CONSERVATION DEPARTMENT DETAILED AGENDA

Date: September 21, 2021

118 Leadmine Lane
 Land Planning
 original plan

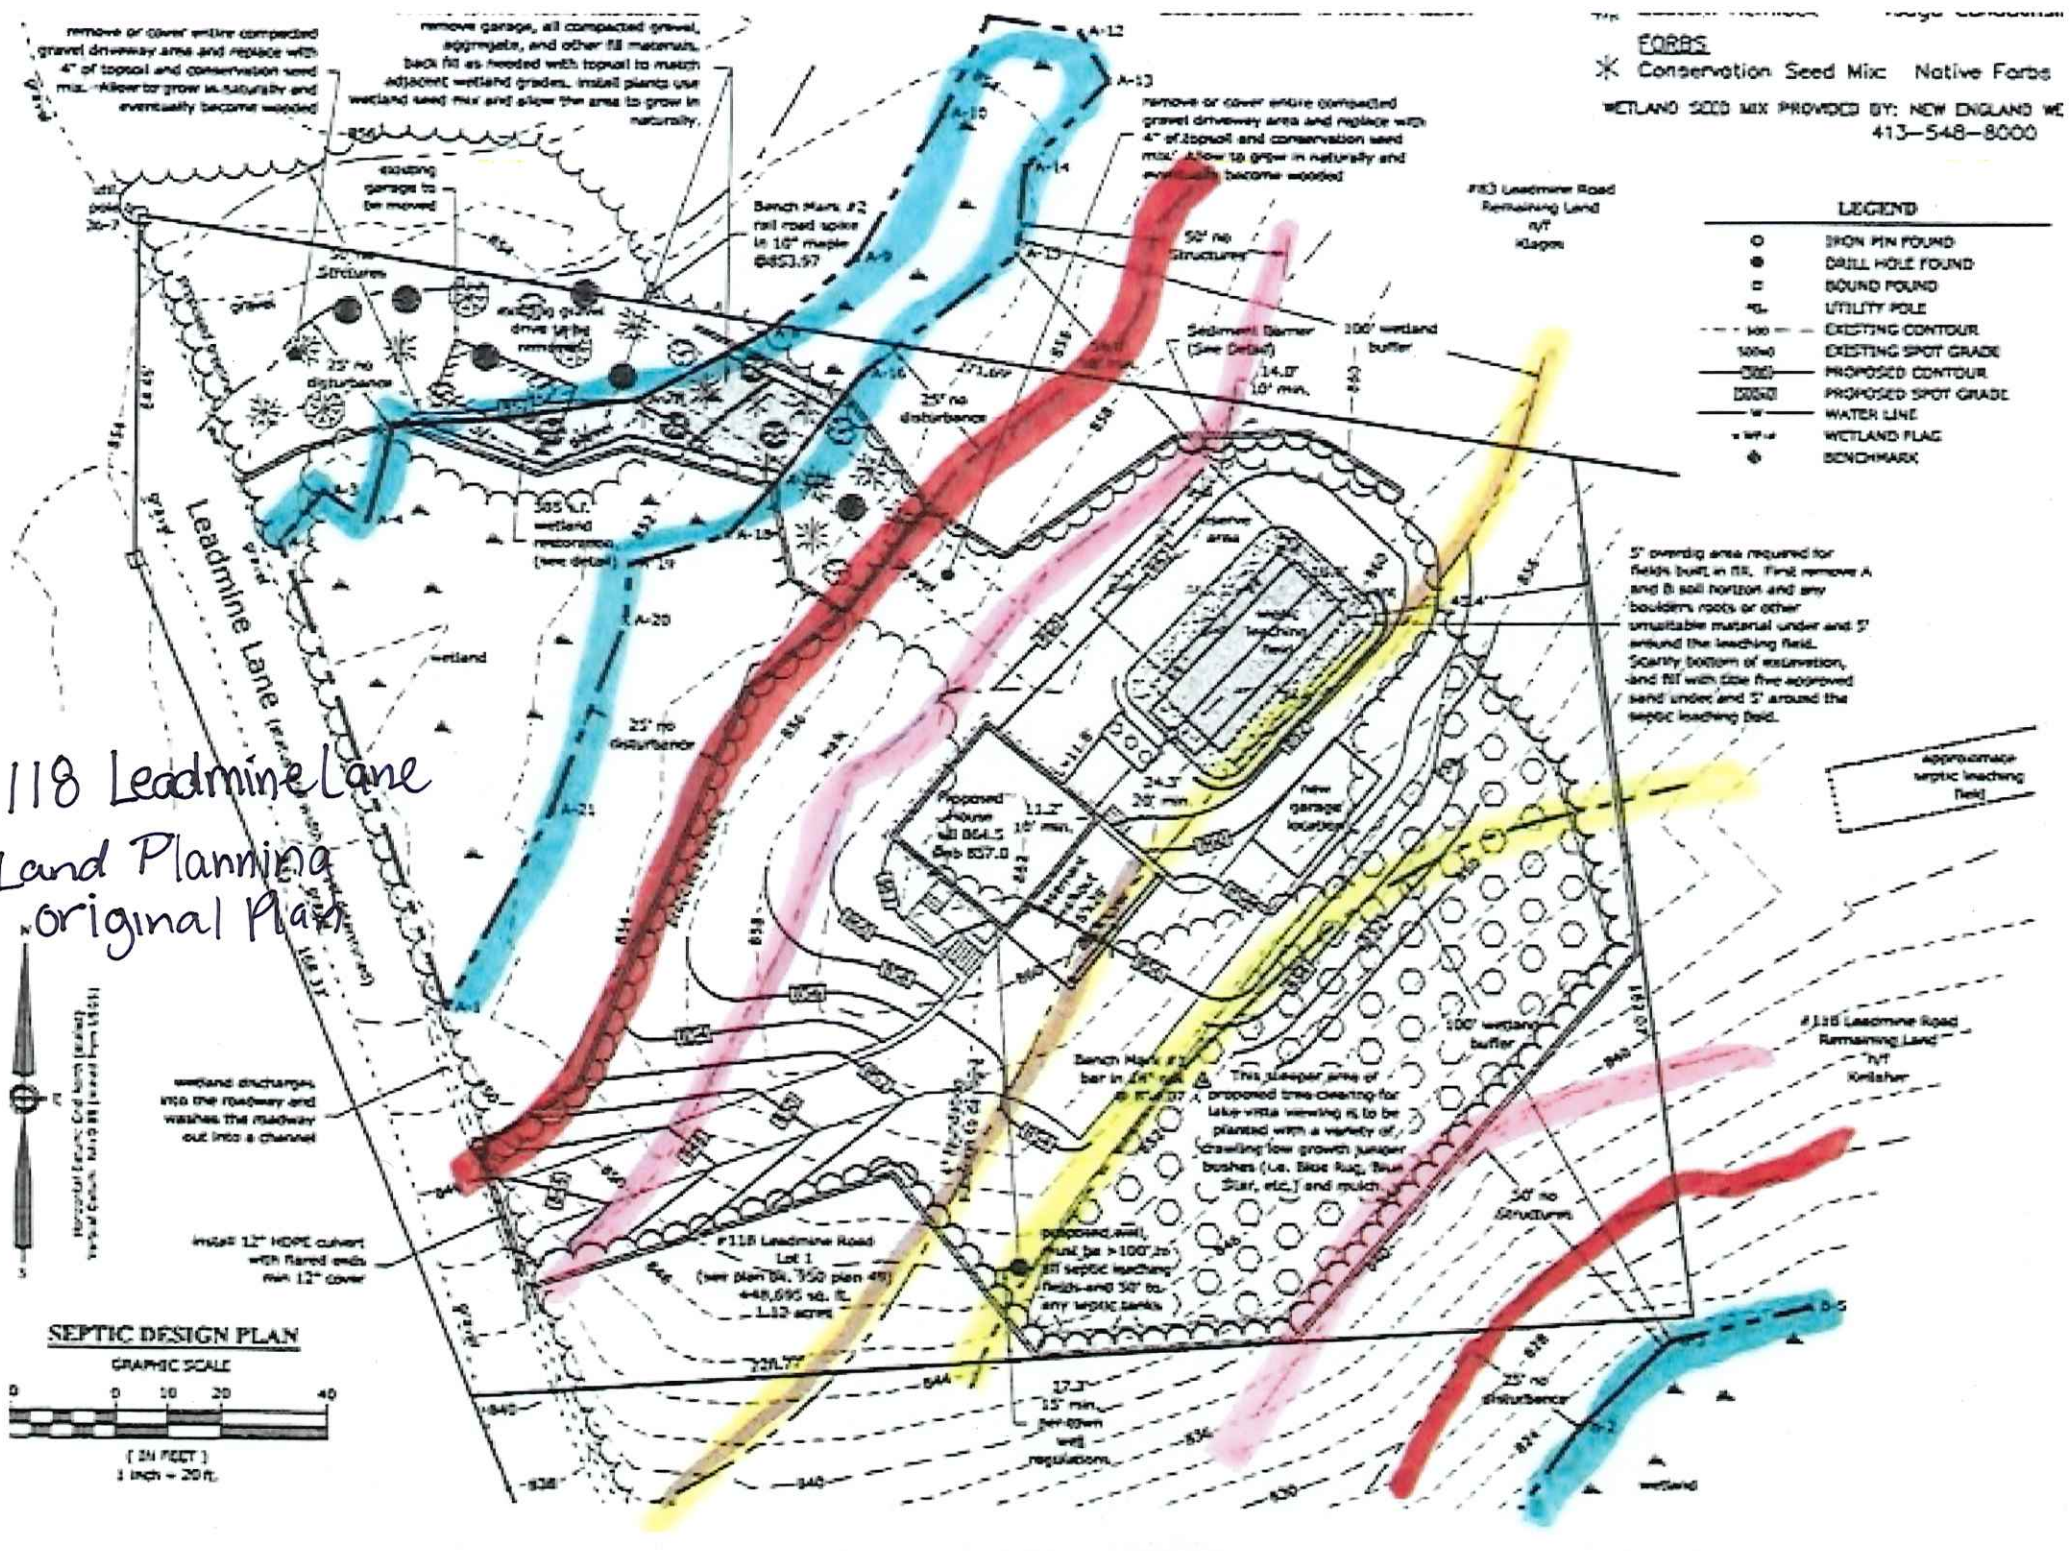
- Two plans are available for review. The original engineer is not working on this project anymore. A new engineering firm has been hired to assist with completion of permitting. The new plan details changes requested by the SCC which include managing driveway runoff and roof runoff from the house and the removal of the vista pruning area and the new proposed tree line. The new plan references the original plan for the septic system and to be used for proposed contours.

- It appears that they have addressed the concerns. Management of the stormwater runoff is important as we have seen significant erosion along Leadmine Lane in this area. Adequate BMPs during work along the driveway will be required.

- Staff Recommendations: If the board is satisfied, staff recommend that the SCC vote to close the public hearing and approve the project through the issuance of Orders of Conditions referencing both site plans. The OOC will need to specifically reference each plan and activities. Conditions should include: standard OOC conditions, conditions for wetland replication monitoring, submission of a plan to include BMPs for erosion control along new driveway during work, and perpetual conditions for maintenance of stormwater management.
